**VILLAGE OF WINDSOR
VILLAGE BOARD RESOLUTION 2023-11**

**APPROVAL OF THE PHASE 7 AMENDMENT TO THE DEVELOPMENT AGREEMENT FOR BEAR
TREE FARMS**

WHEREAS, the Village Staff and Consultants have reviewed the Petitioner’s request and prepared a Staff Report dated February 09, 2023 (the “Staff Report”) recommending approval, subject to certain conditions specified in the Staff Report; and

Project No: 122.1386.30
 Sheet C 204

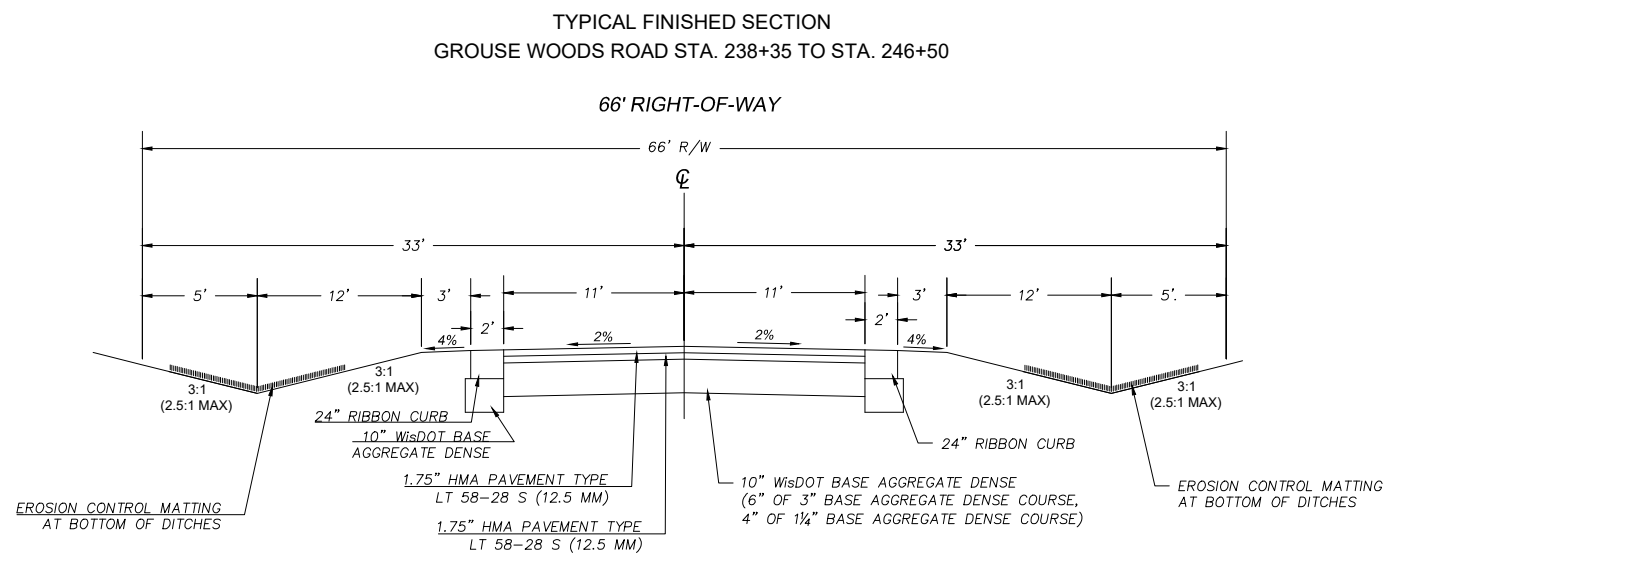
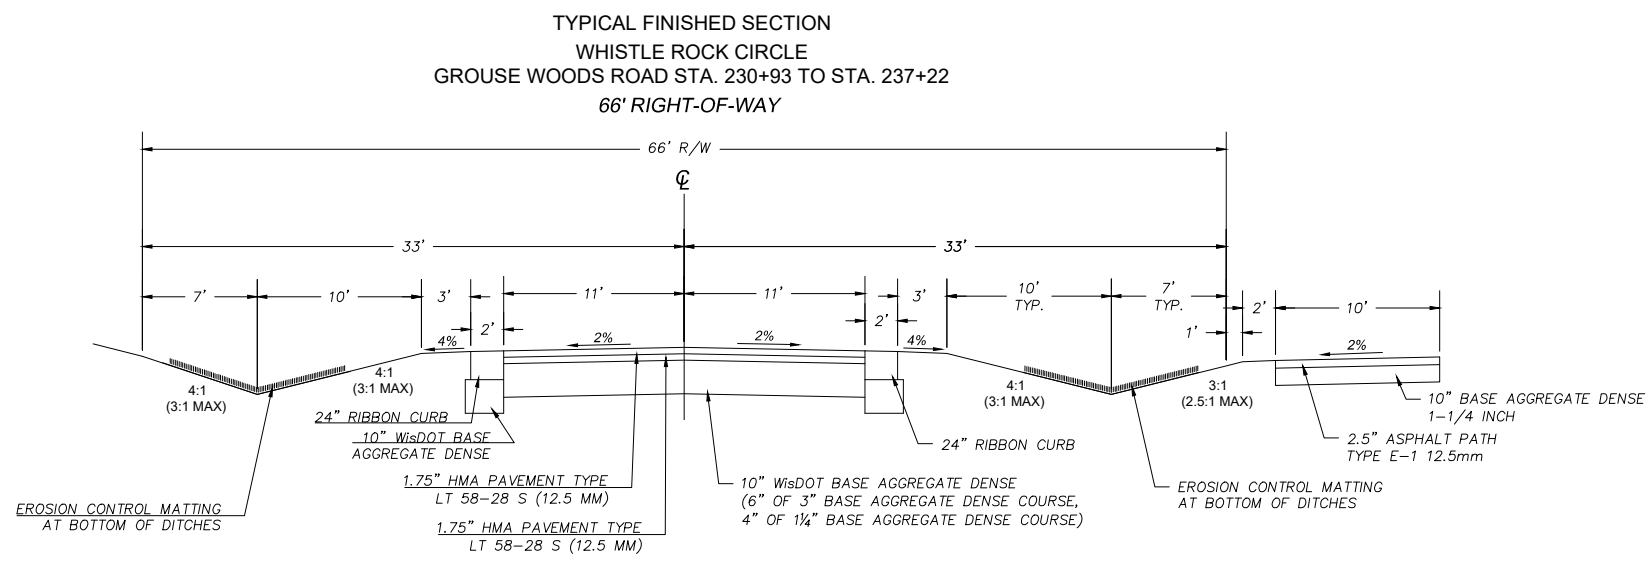
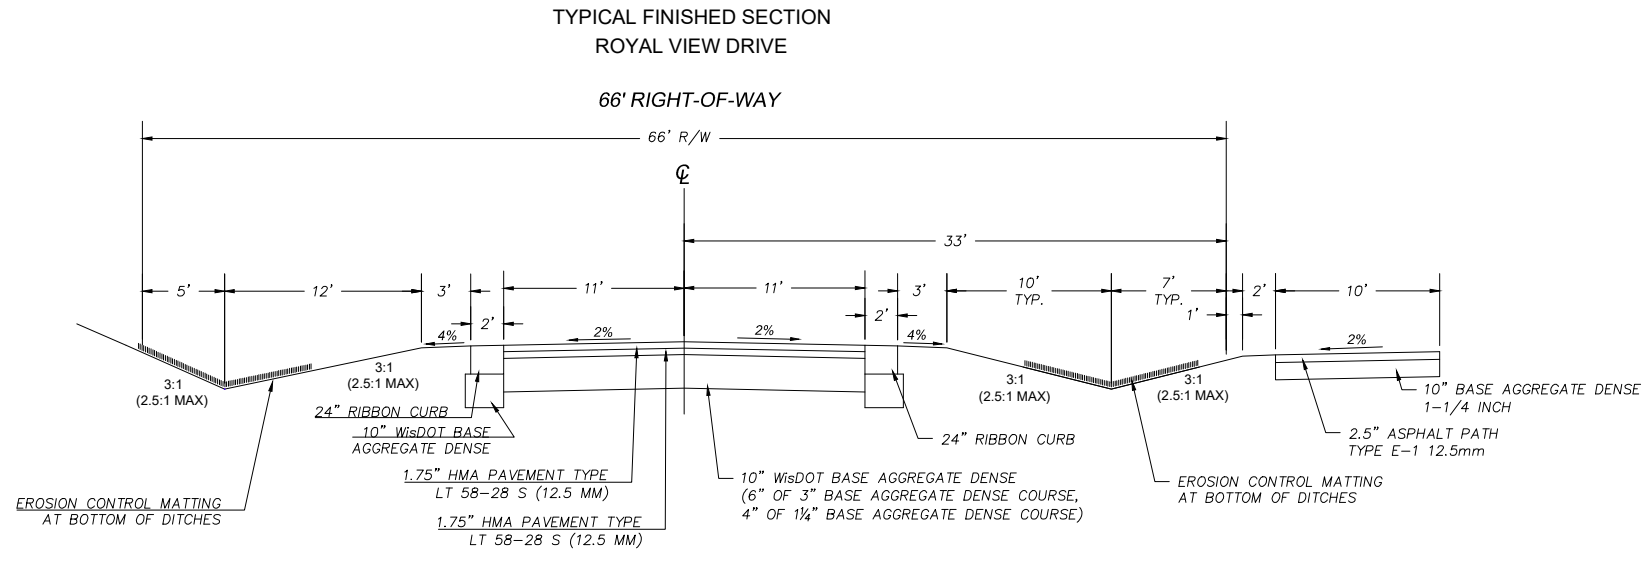
3. Sheet C 204: Ditch slopes should have a max of 3:1.
4. Sheet C 403: Additional grading may occur in Phase 8 to maximize sanitary sewer discharging to sanitary manhole located at station 293+00.

Sheet C 404

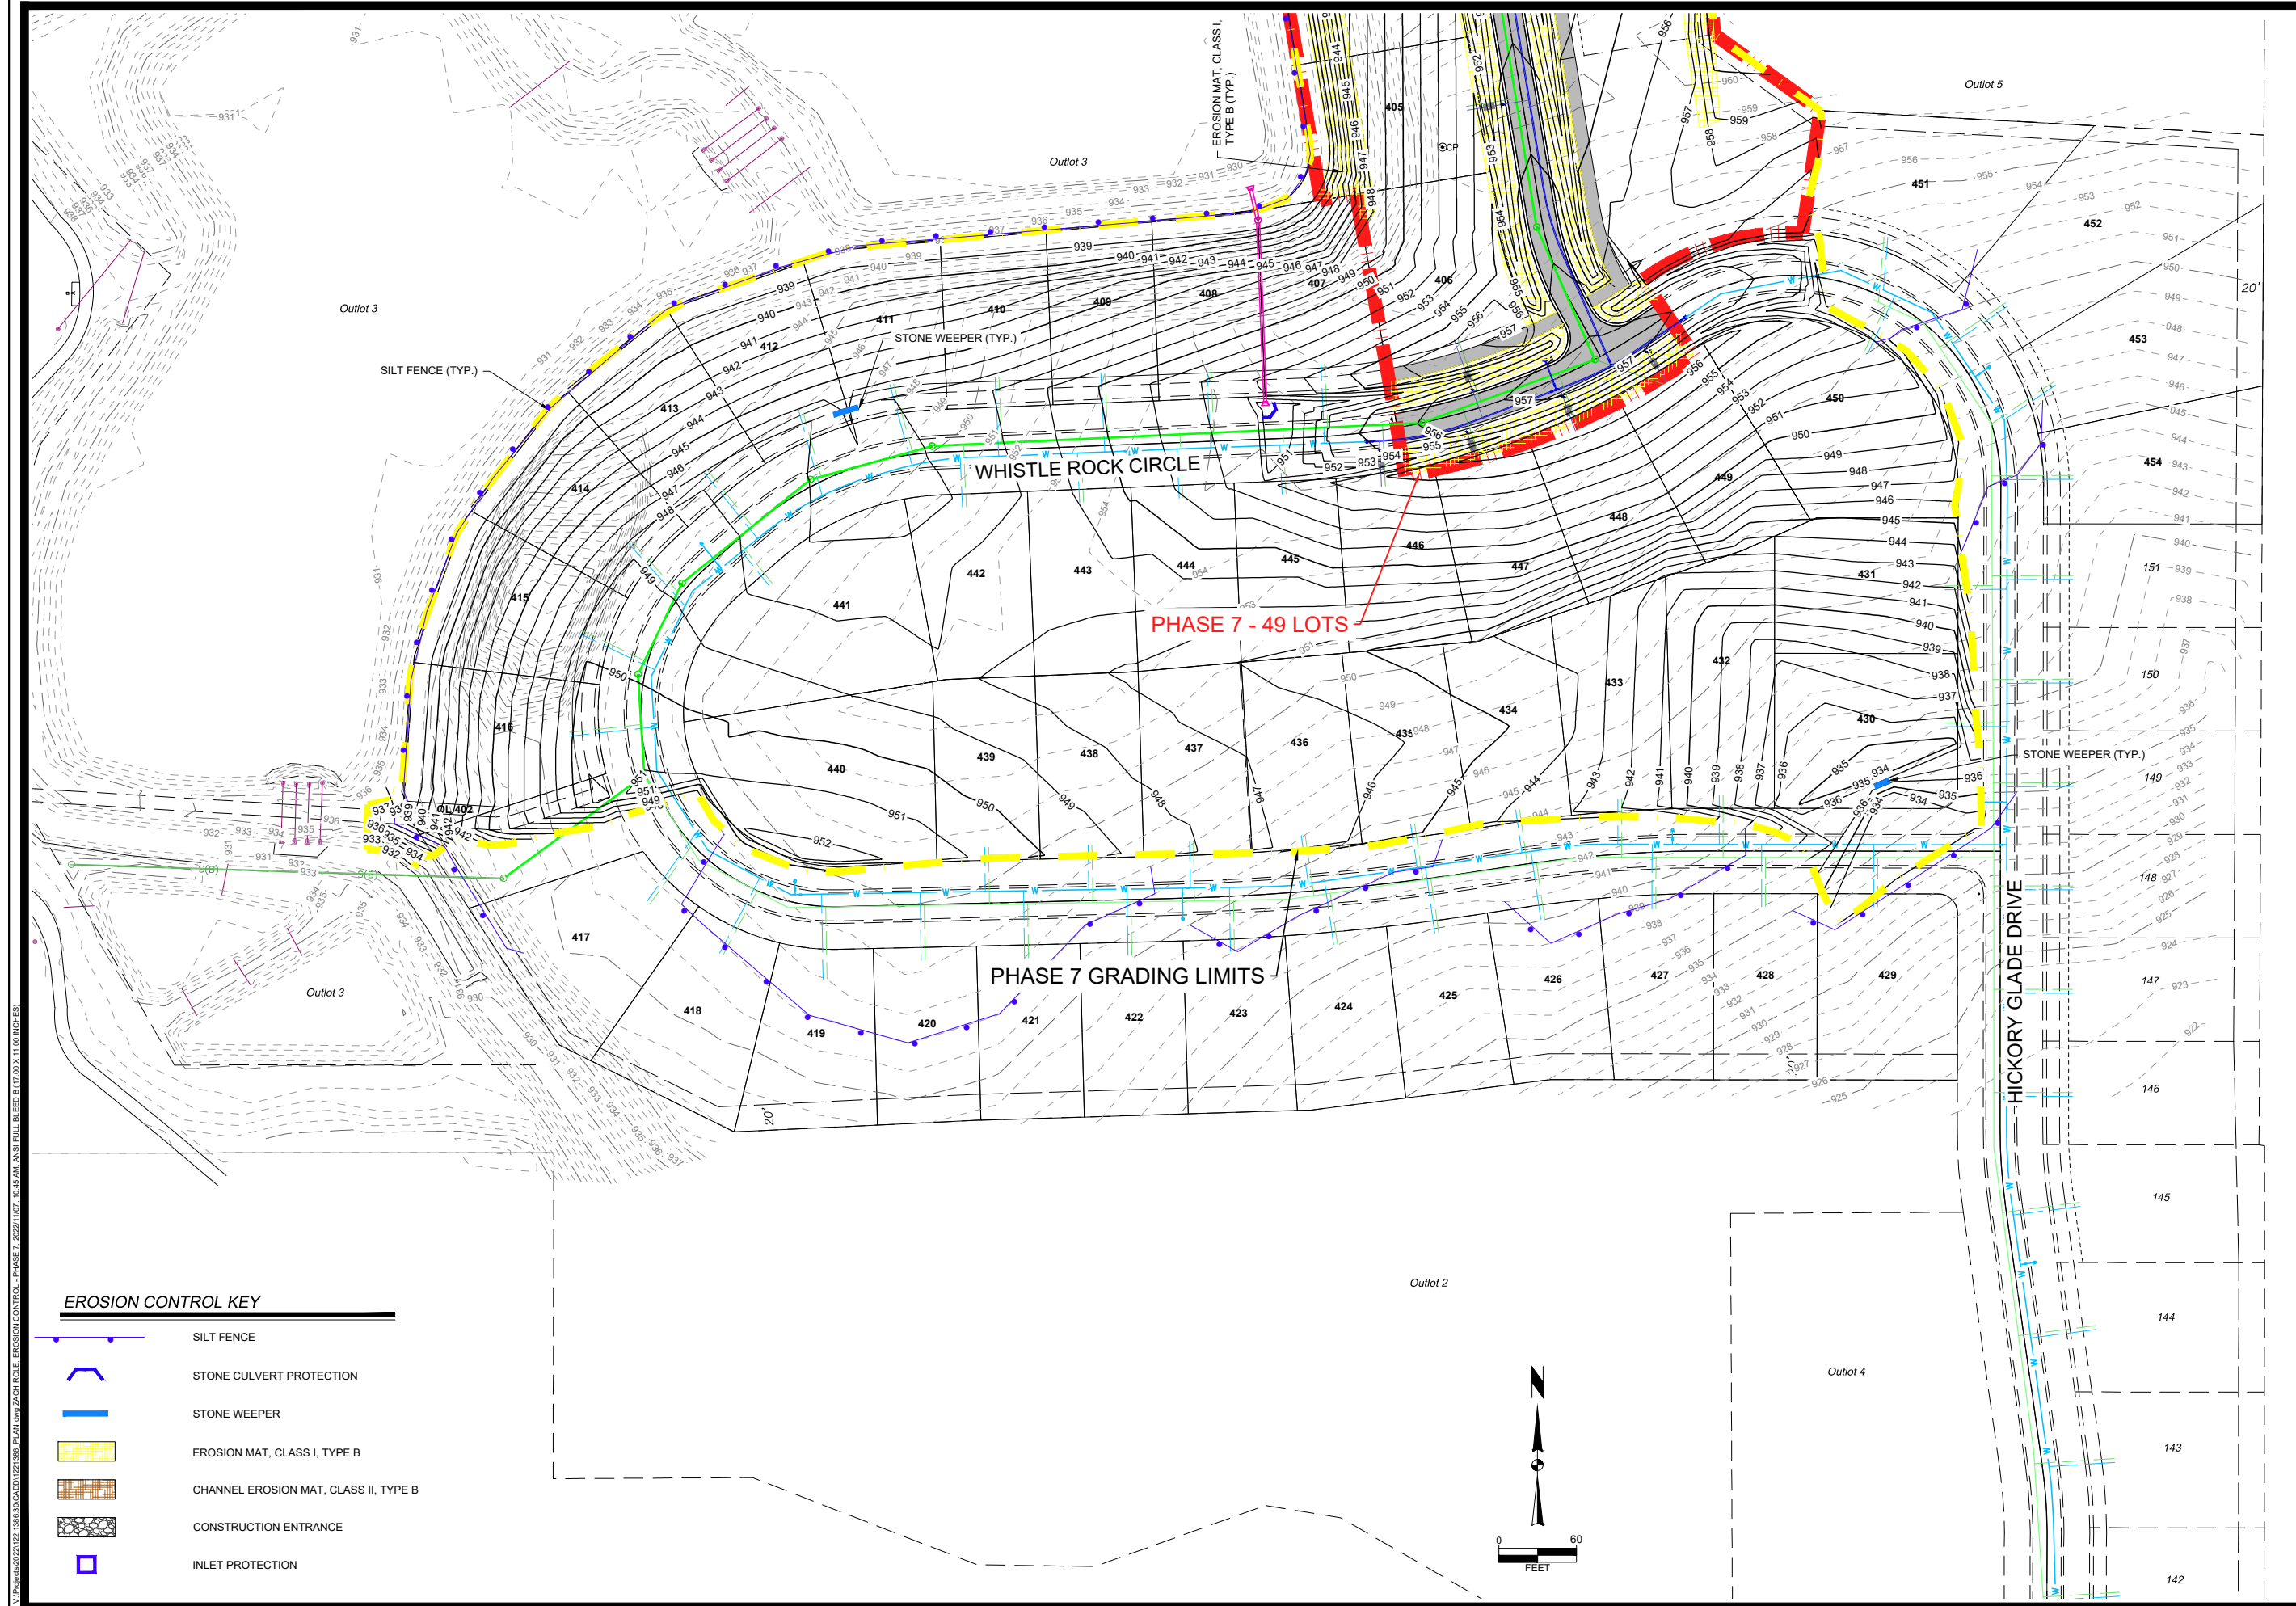
5. Sheet C 404: Construct erosion protection in the ditch lines at the existing westerly connection with Royal View Drive.
6. Sheet C 503: Pipe SAP-1 and SAP-23 shall be constructed at DNR minimum of 0.4% to accommodate future sanitary sewer constructed in Phase 8.

Project No: 122.1386.30
 Sheet C 504

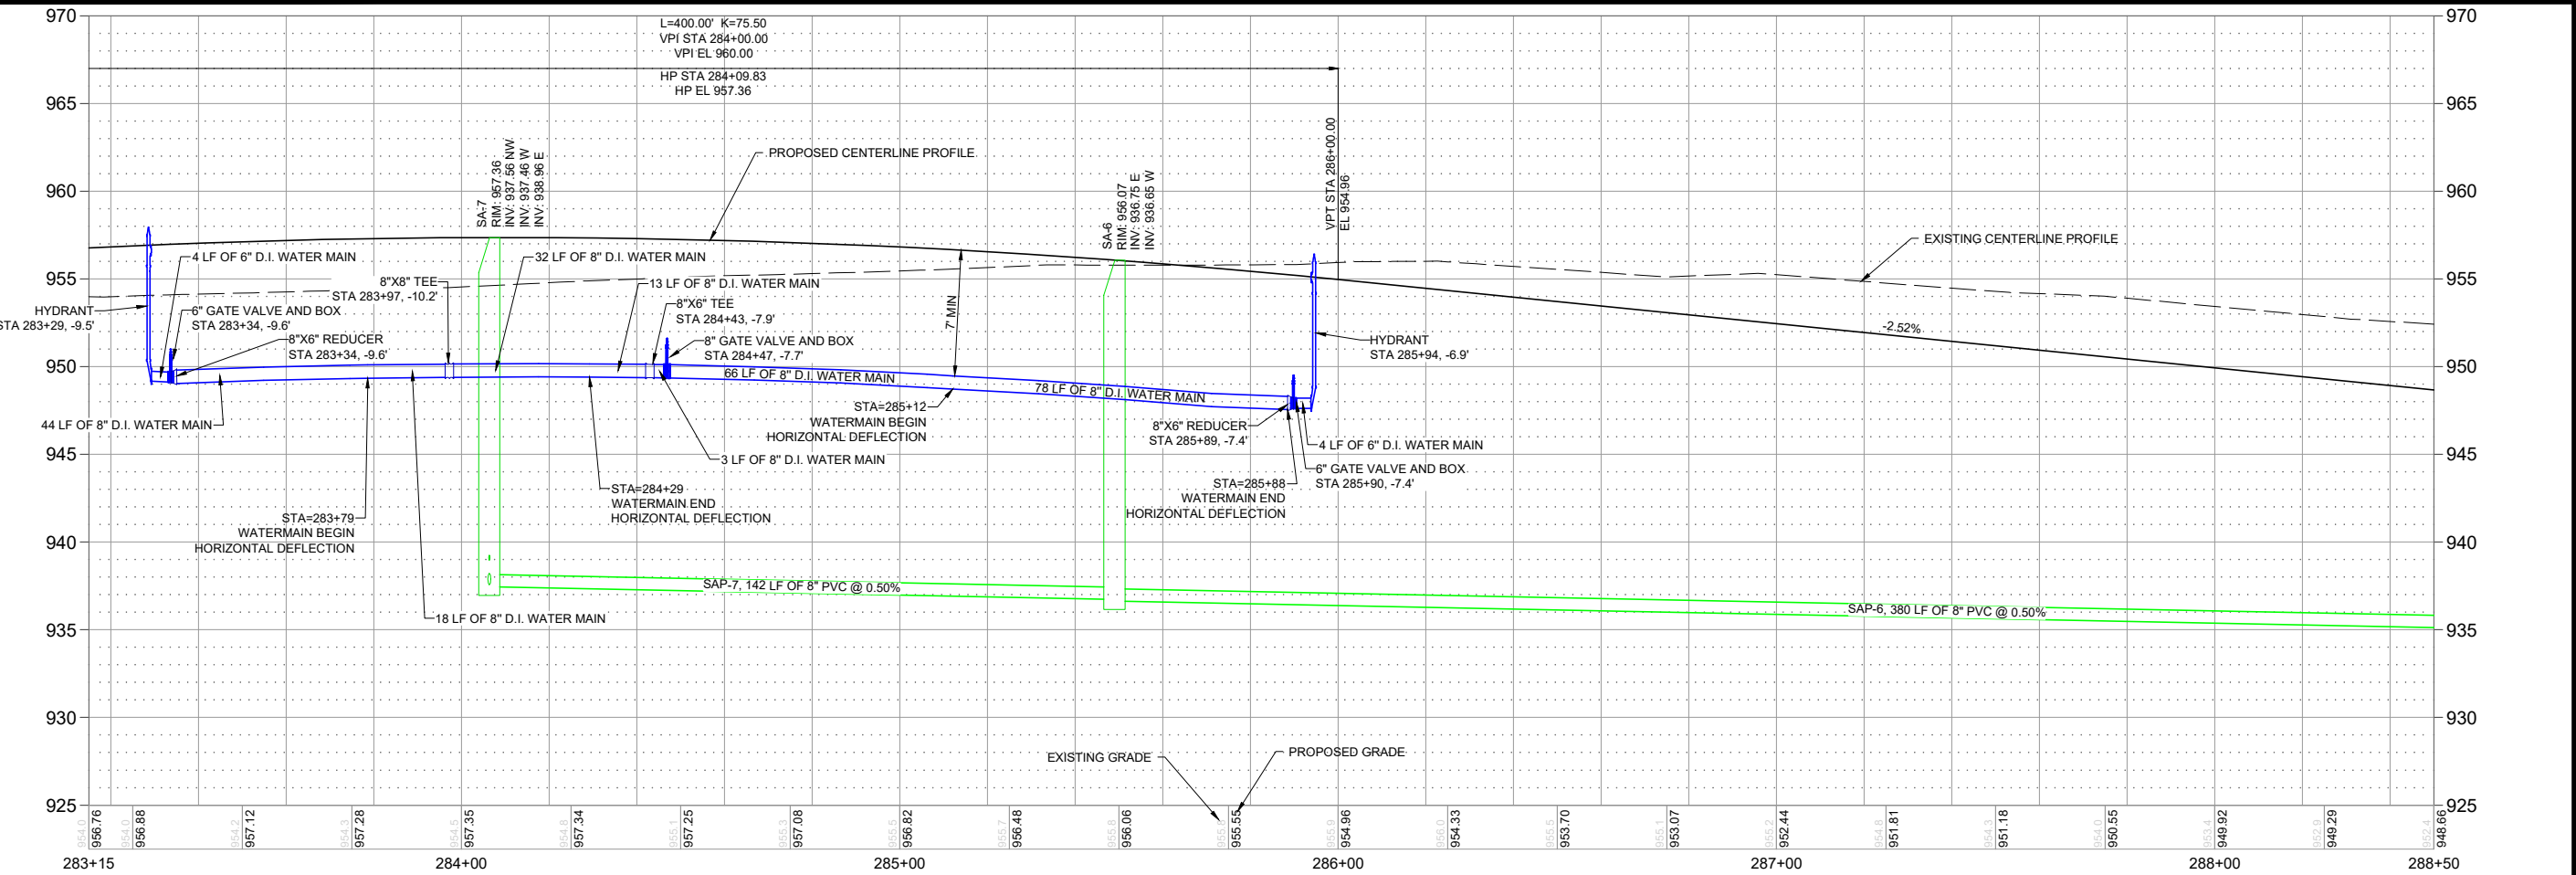
7. Sheet C 504: A temporary tee-turnaround is suggested at the dead-ends of Whistle Rock Circle for large-vehicles to turn around. The watermain profile should be modified to construct the high point at the hydrant located at station 284+42. An 8" gate valve should be constructed east of the watermain tee to properly isolate water main.
